Access Compliance Report

Public Rights-of-Way

| Intersection ID: 2698 | Main Street: GRABURN'S_FORD_DR | Cross Street: HIGHLAND_CREEK_PY | Location: NE |
| ADA ID: 34DEBDC75A3D | Ramp Type: Perp | Initial Pass/Fail: Fail | Overall Compliance: No |

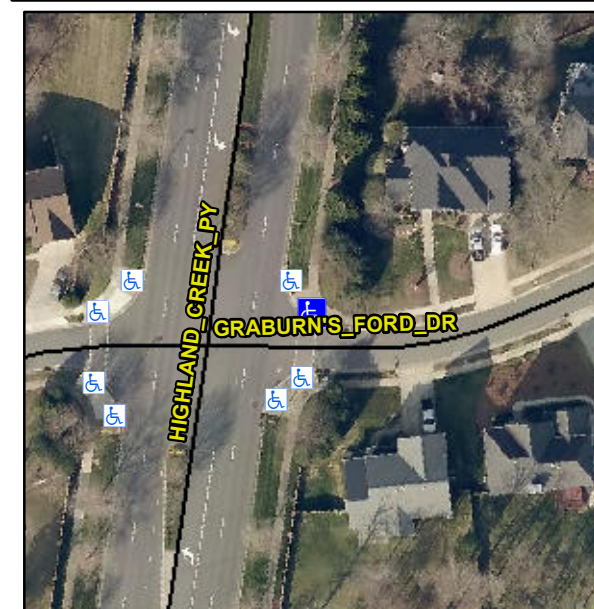
R304.5.1, R304.2.2, R304.5.3

| Compliance | Description | Data | Compliance | Description | Data |
|------------|-----------------------|------|------------|-----------------------------|------|
| N/A | Ramp Length (in) | 66.0 | No | Ramp Slope (%) | 8.7 |
| No | Ramp Width (in) | 47.0 | No | Ramp XSlope (%) | 5.6 |

Remove & Replace Entire Ramp.
